Item ID: D206-667-147TRN

Item Name: Crosstube Assembly, Mid Fwd

DRAWING NO. D206-667-147	TITLE CROSSTUBE ASS'Y (206L MID FWD)	REV. A	DART AEROSPACE LTD ENGINEERING ORDER	D.E.O. NO. D206-667-147-A-1	SHEET NO. SHEET 1 OF 1	SCALE NTS
DRAWN 90	CHECKED A.S.S.	MFG. APPR. [Signature]	APPROVED [Signature]	DE APPR. [Signature]		
DATE 11.07.15	DATE 11.07.20	DATE 11.07.21	DATE 11/07/21	DATE 11.07.21

PURPOSE:

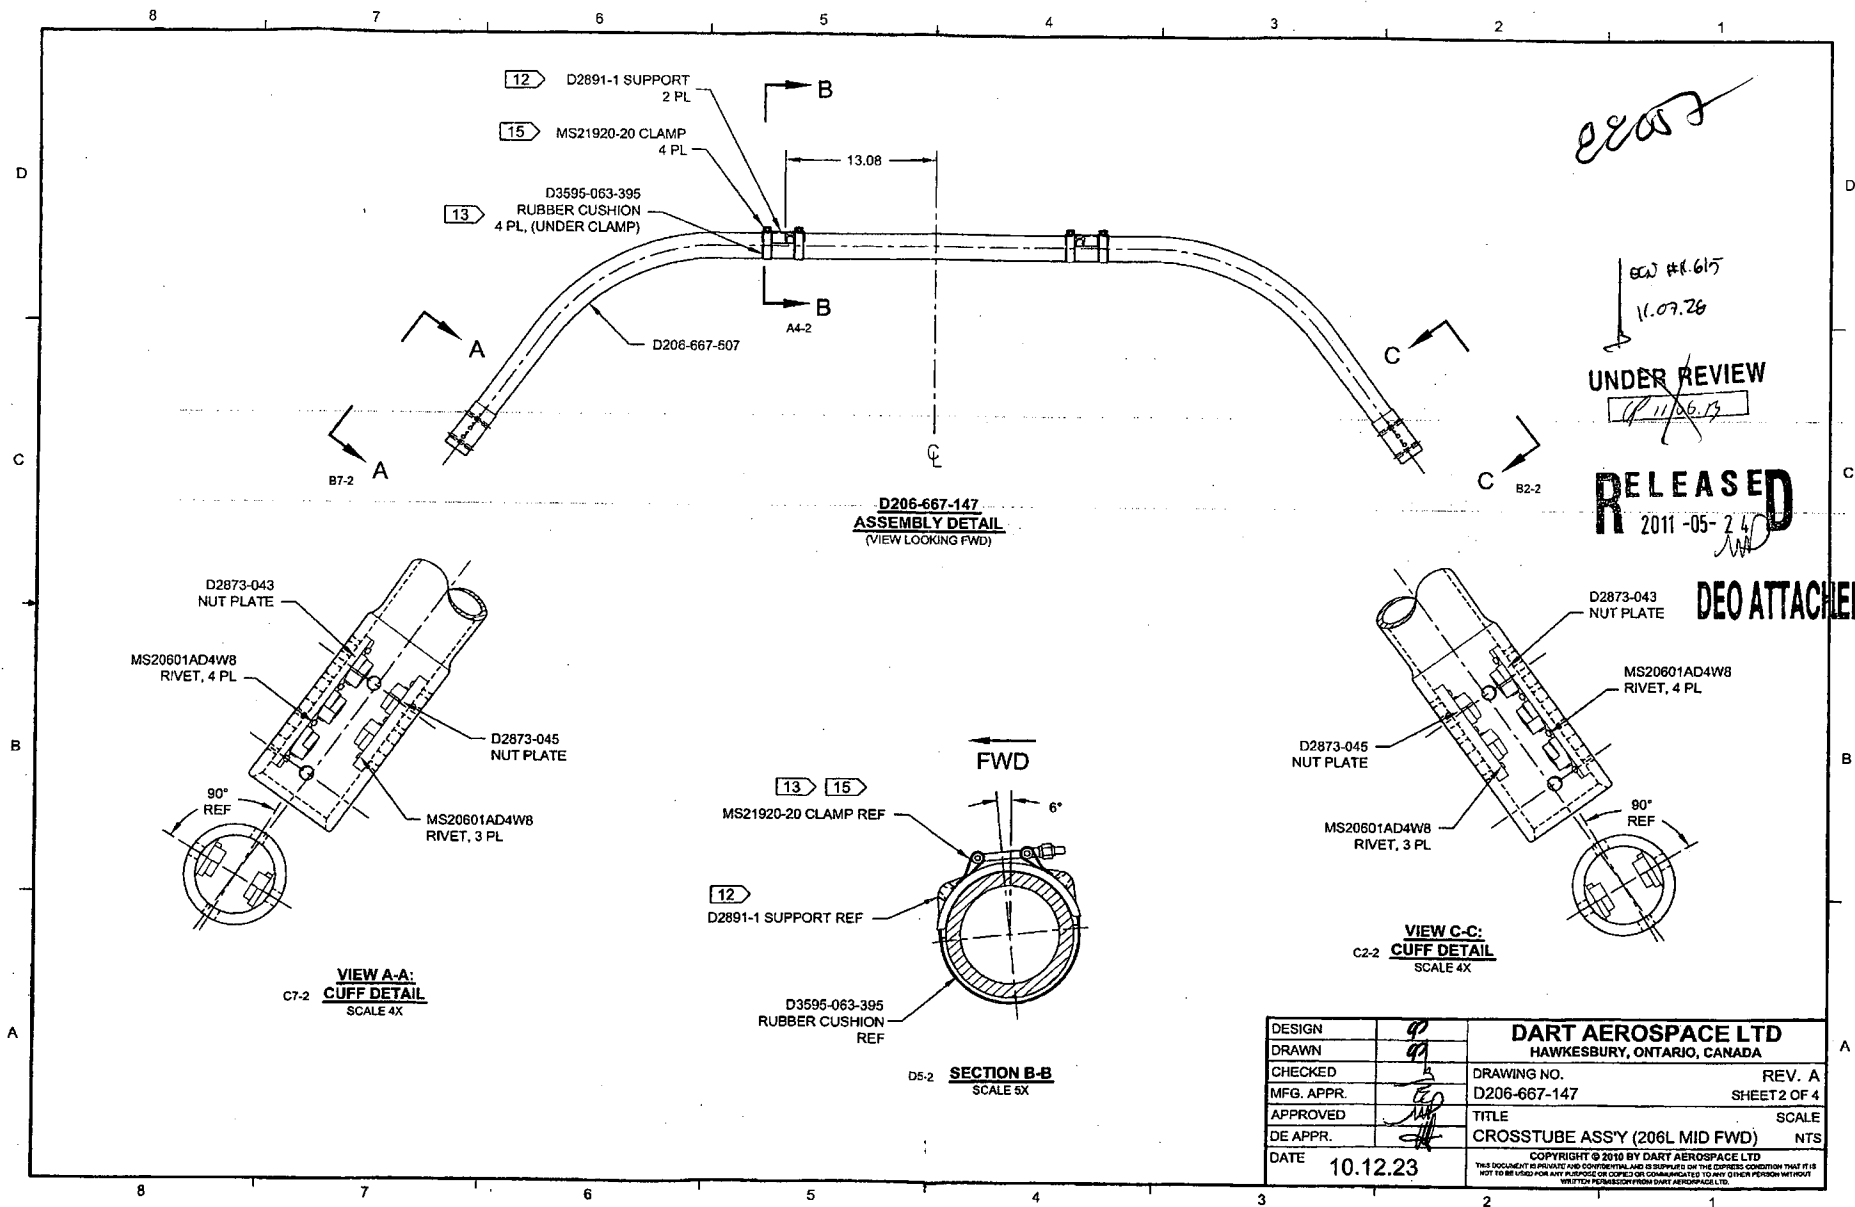
REPLACE MAGNOBOND WITH PROSEAL.

NOTE 12 & 15, SHEET 1 IS AMENDED AS FOLLOWS:

Item	Qty -147	Part Number	Description
9	A/R	PROSEAL 890 B-2	SEALANT, AMS-S-8802 CLASS B-2

- 12) TO INSTALL D2891-1 SUPPORT: ABRABE MATING SURFACE OF SUPPORT AND CROSSTUBE WITH 180-GRIT SANDPAPER AND REMOVE RESIDUE WITH MEK (OR EQUIVALENT). APPLY A 0.04" TO 0.07" THICK LAYER OF PROSEAL 890 CLASS B-2 (OR AMS-S-8802 CLASS B-2) SEALANT TO MATING SURFACE OF SUPPORT.
- 15) TORQUE CLAMPS 80 TO 100 IN-LB. ENSURE AT LEAST 1.5 THREADS SHOWING IN SAFETY AND THAT NUT HAS NOT BOTTOMED-OUT AFTER TORQUING. **PRIOR TO PACKAGING, RE-CHECK TORQUE ON CLAMPS AFTER PROSEAL 890 SEALANT HAS CURED FOR 72 HOURS.**

DETAIL M:
CUFF TRANSITION
NOT TO SCALE

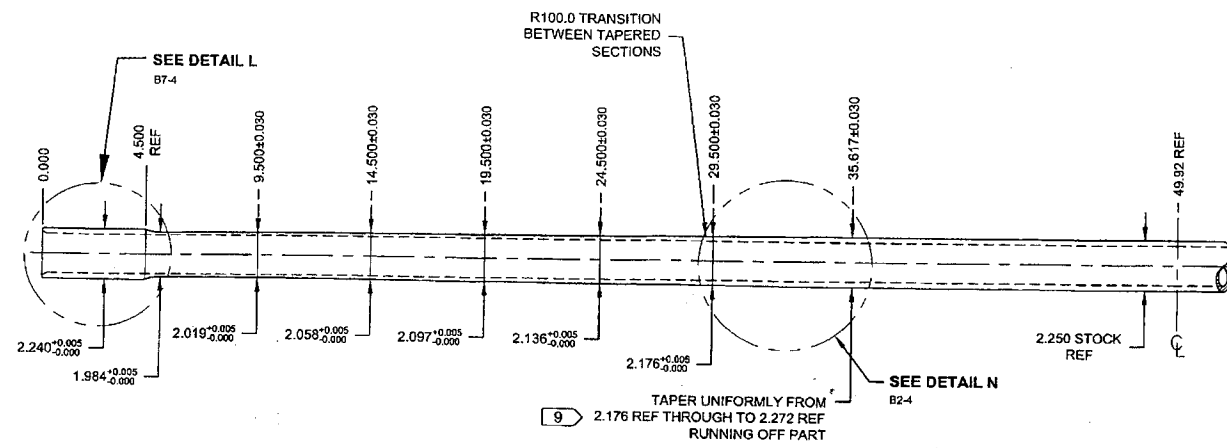
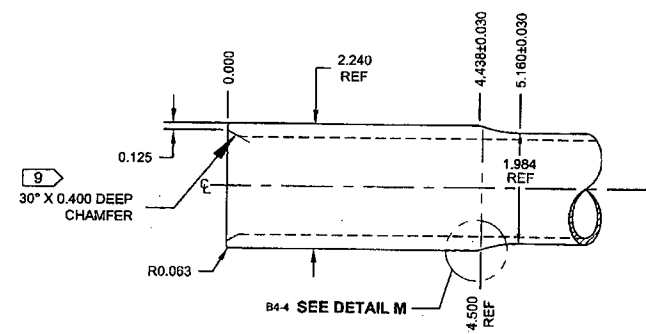
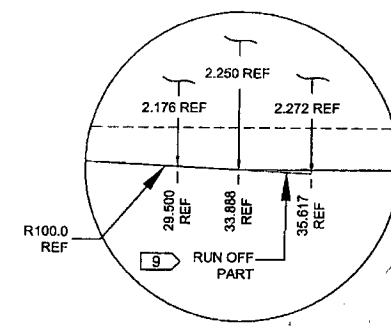
Root Cause	Date	Step	Qty	Description of work order update or Non-conformance	Initial Chief Eng	Action Description	Sign & Date	Verification	QC Inspector		
Doc/Data <input type="checkbox"/>	12/8/13	100	1	Cuff is 0.002" below tolerance on O.D.	 12/8/13	Acceptable	 12/8/13	 12/06/13	 12/06/13		
Equip/Tooling <input checked="" type="checkbox"/>											
Operator <input type="checkbox"/>											
Material <input checked="" type="checkbox"/>											
Setup <input type="checkbox"/>											
Other <input type="checkbox"/>											
Process <input type="checkbox"/>											
Supplier <input type="checkbox"/>											
Training <input type="checkbox"/>											
Unapproved <input type="checkbox"/>

Cuff out of
tolerance
